## Product / Process Change Notification (PCN)

**PCN #:** PCN\_IndXHMI\_20181023

**Affected Series:** WE-XHMI-6030, 6060, 8080, 1090, 1510;  
744393xxxxx

1510

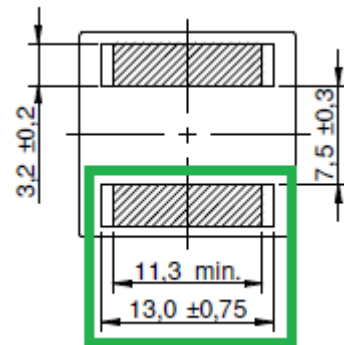
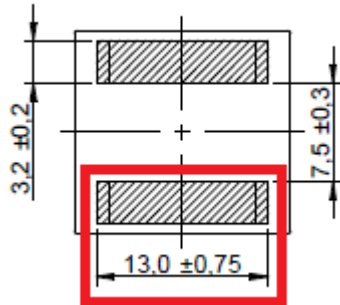
The following additional dimensions will be specified on the bottom view of the part:
